Florida Department of Transportation

DCE MEMORANDUM NO. 09-18

SUBJECT: PAVEMENT MARKING MATERIAL CERTIFICATION

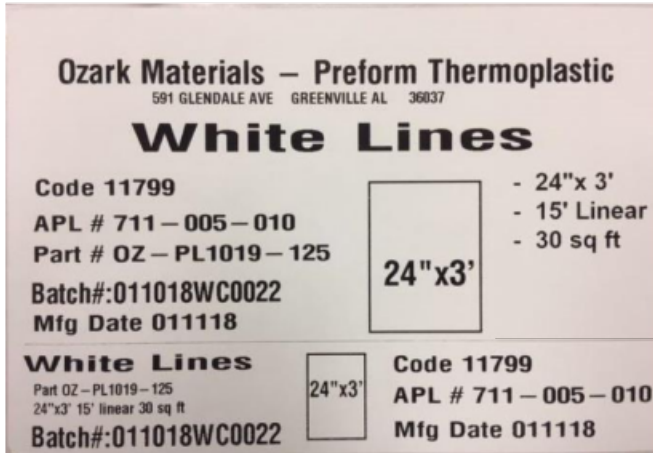
Specification 971-1.1 Packaging and Labeling requires the name and address of the manufacturer be shown on the label. The label must also show the color, date of manufacturer, lot number and APL number. An example of this requirement is shown below for reference.

The Department will now allow 701, 709, and 711 materials with labels as shown above to be provided for pavement marking materials that meet the requirements of 971-1.1 without providing material certifications. This material acceptance memorandum does **NOT** apply to Specification 710 Painted Pavement Markings as it will still require material certifications.

This memorandum serves as a blanket approval to process a \$0.00 contract change to accept products noted when labeled as shown above and should be attached to the Work Order or Supplemental Agreement for all active contracts that include pay items in Specifications 701, 709 and 711.
